# MEADOW OAKS ADDITION

METROPOLITAN AREA PLANNING  
DEPARTMENT

May 21, 1993

Re: S/D 93-27 MEADOW OAKS ADDITION (Final Plat)

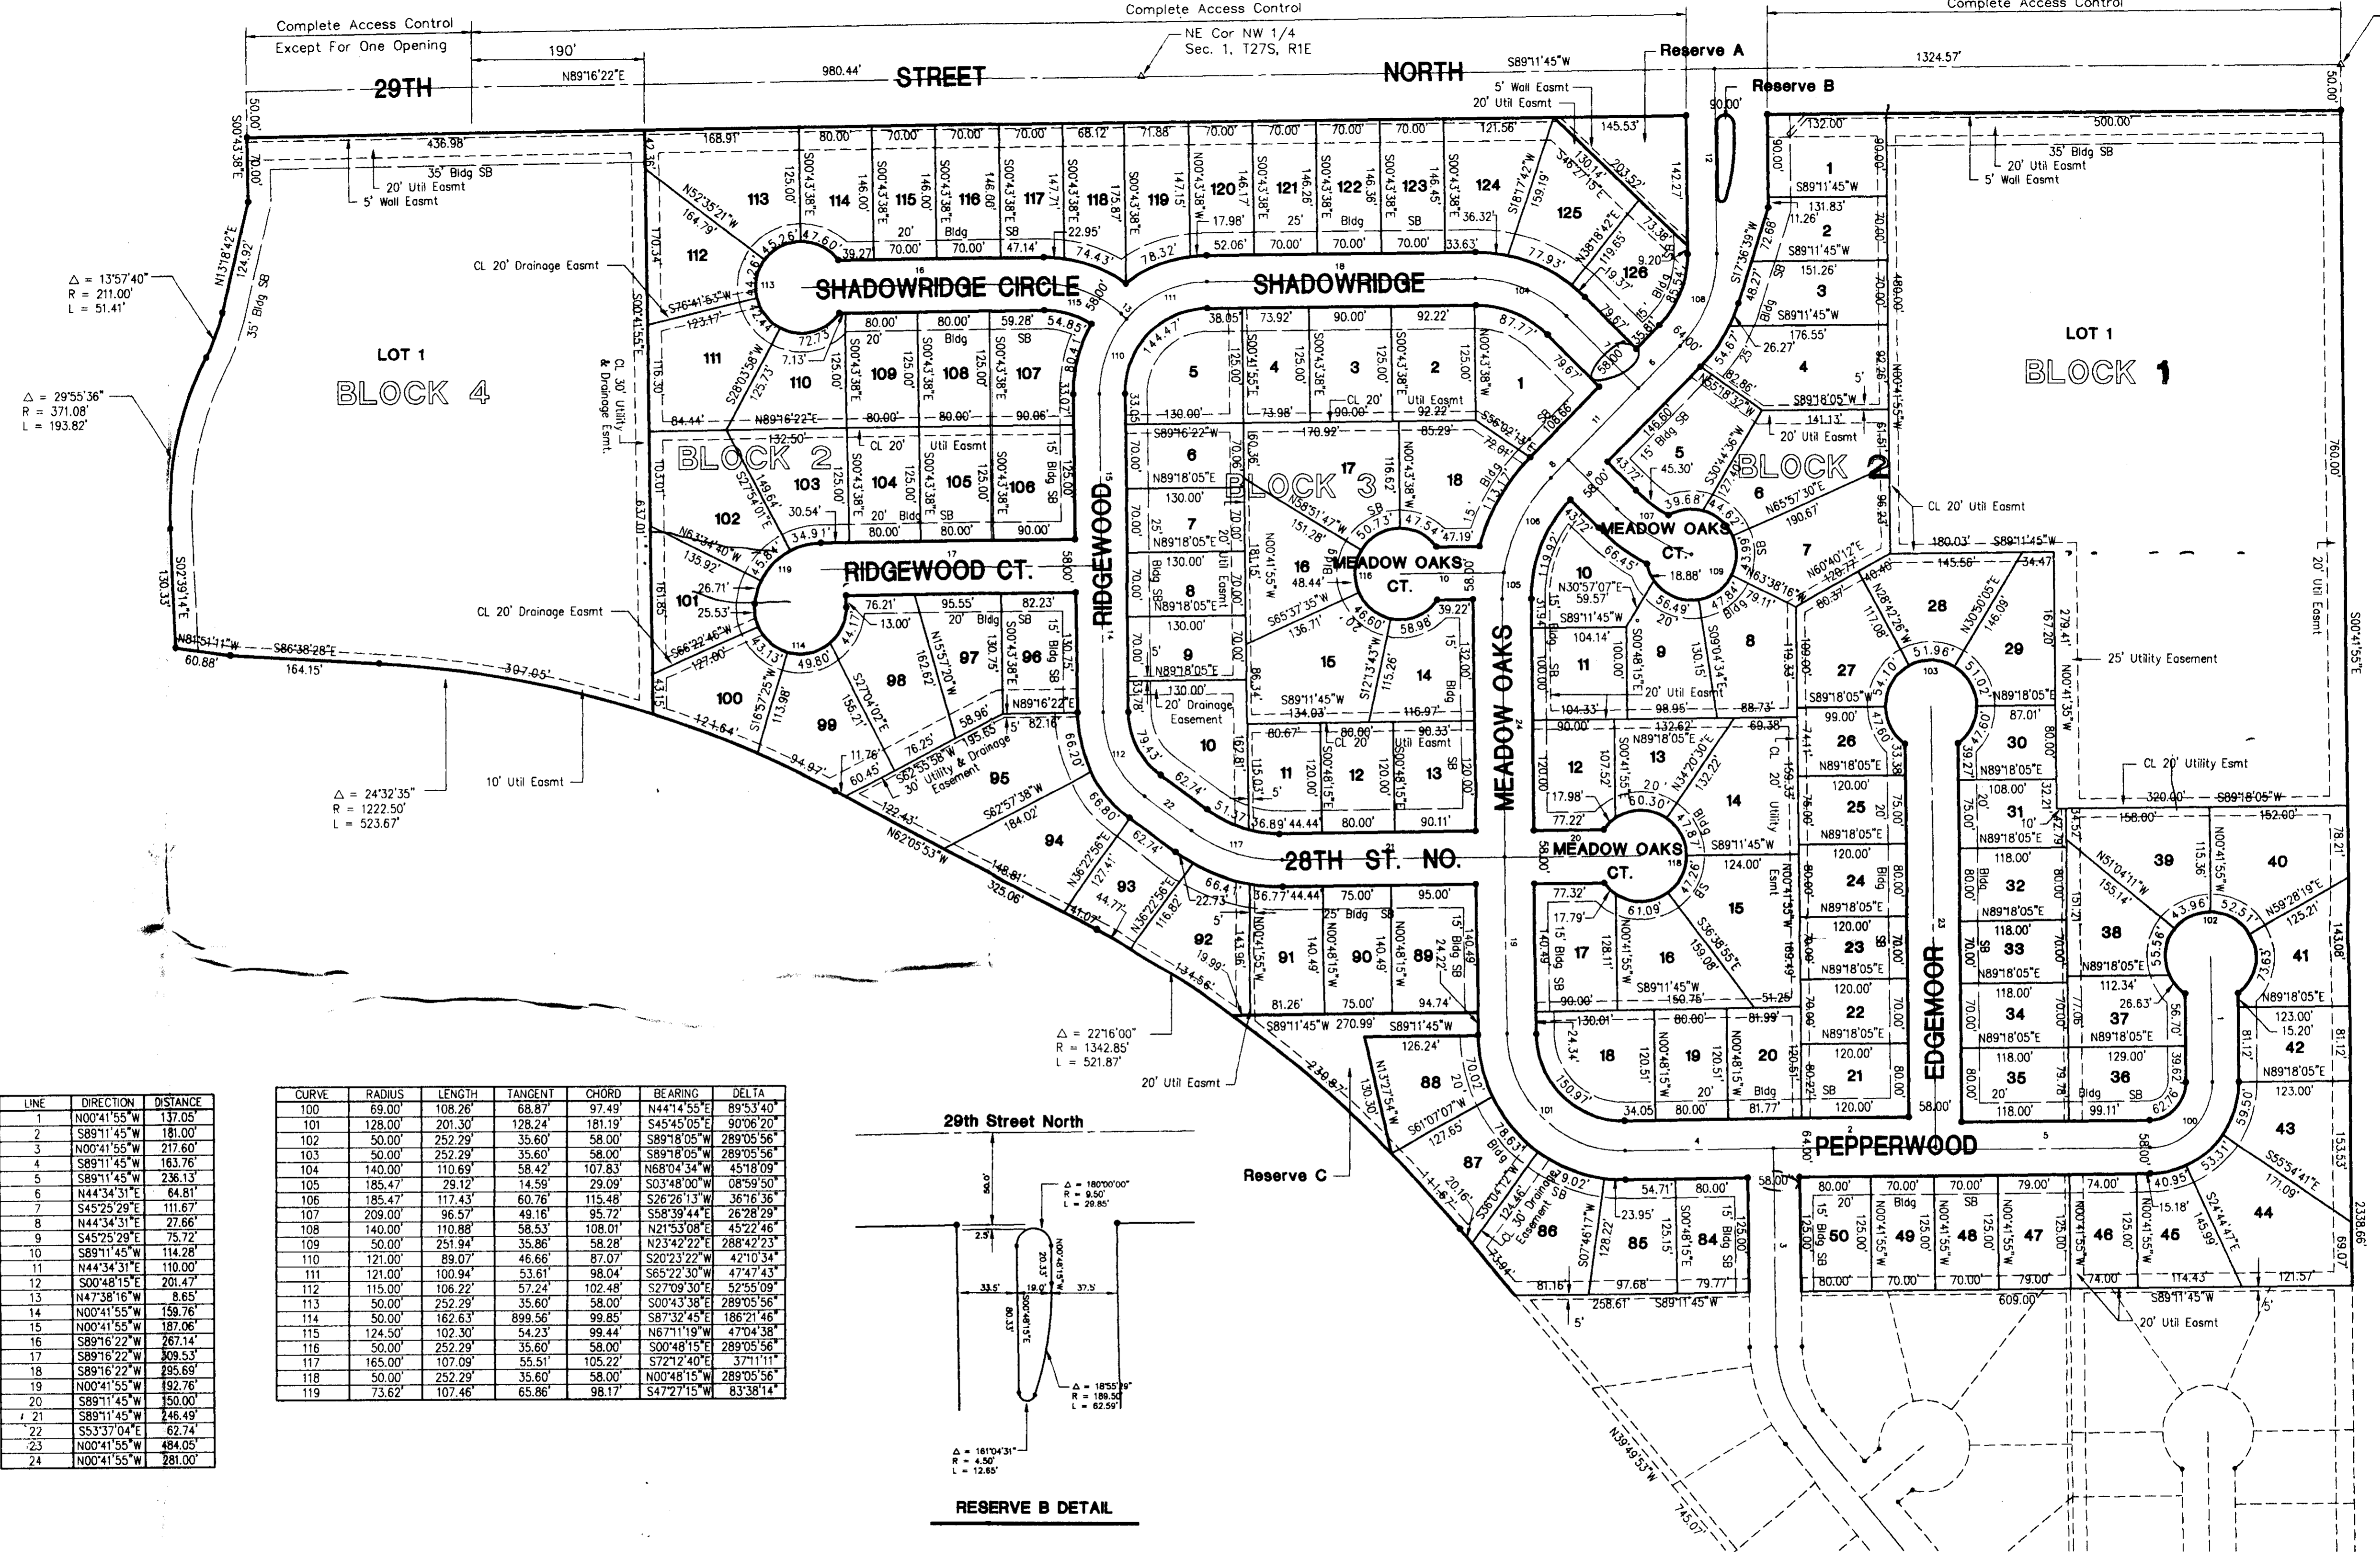
- T. On the final plat tracing, the word Block and the associated numbers shall be more boldly or distinctly indicated.
- U. In terms of street names, the suffix Circle should be used in the following cases; Pepperwood east of Edgemoor and Edgemoor north of Pepperwood. The following street name changes shall also be made: Ridgewood Ct. to Parkwood Ct. and Charlotte to Meadow Oaks Ct.

- V. On the final plat tracing, the Mayor's signature block shall be amended to indicate Elma Broadfoot as Mayor.
- W. The final plat shall indicate the utility easements requested by K.G. & E. which are indicated on the enclosed "marked" copy of the plat.

- DD. On the final plat tracing, minimum building pad elevations shall be established for lots adjacent to the drainageway along this plat's south line. These minimum pad elevations shall be shown on the face of the plat and referenced in the plat's text. It shall be indicated if these elevations are for the lowest opening or level. Both on-site and off-site benchmarks shall also be indicated.

In order to accommodate the above sidewalk, a pedestrian easement needs to be granted and shown somewhere in the vicinity of Lots 41, 42, and 43, Block 2 and the platting text shall note the granting of such an easement. Required covenants for this Addition shall also indicate that the Addition's homeowners' association will be responsible for maintaining the sidewalk in this easement.

- H. Both on the CUP and the approved plat the streets now being indicated as Shadowridge/Ridgewood/28th Street North were indicated as being platted with a 64-foot right-of-way. Based on the number of lots directly and indirectly accessing these streets, the present Subdivision Regulations would also require that these streets be platted at the 64-foot standard. The final plat shall therefore indicate these streets at the 64-foot right-of-way standard.

I. Unless a cemetery is intended for Lot 1, Block 1, an amendment to the CUP will be needed to allow any such use as a church or apartments at this location. Further, no access is shown to this site except what would be allowed from 29th street North. However, this plat and the CUP are both indicating complete access control to 29th Street North across this lot's north property line. Assuming that the applicant does desire access to this lot from 29th Street North, the applicant will need to amend the CUP to allow for such access and the final plat shall also reflect such an access request. That is, the face of the plat and the plat's text will need to indicate the access being allowed to this lot.

The need for such an emergency access easement is, though, still as great. Such an easement shall therefore be provided somewhere in the area of Lots 113 through 115, Block 2, running from 29th street North to Shadowridge Circle. The plat's text shall also reference this easement and covenants shall be provided indicating that the homeowners association will be responsible for maintaining this access easement. As indicated in the Subdivision Regulations, the applicant shall submit any needed guarantee for the installation of a driving surface, gates, fences, etc. required for such an easement.

- N. On the final plat tracing since an opening is being indicated to 29th Street from a portion of Lot 1, Block 4, the word "complete" shall be deleted from the face of the plat. This access should also be noted in the plat's text. As now written, the text indicates that all lots have complete access control to 29th Street.

- O. On the final plat tracing, Beacon Hill adjacent to the west line of Lot 1, Block 4 shall be indicated. The center line of this street shall be labeled, with street right-of-way also indicated.

- P. On the final plat tracing, and as indicated by the CUP, 25-foot building setbacks were to be indicated for the frontages of all lots adjacent to streets with 64-foot rights-of-way. This includes the 64-foot streets requested above; also any 64-foot streets already shown on this plat, such as Pepperwood. Corner lots may indicate a 15-foot building setback for the intended sideyard.

- Q. Since Reserves A and B are indicated as being platted for structures, a 25-foot building setback shall be indicated to 29th Street North. Reserve A shall also indicate a sideyard setback to Meadow Oaks.

- R. The applicant is advised that the guardhouse being indicated for Reserve B cannot be used in any way to inhibit public access into or out of this Addition. That is, Meadow Oaks is being platted as a public street and such access cannot be interfered with.

- S. On the final plat tracing, the centerline of 29th Street North shall be labeled (CL).
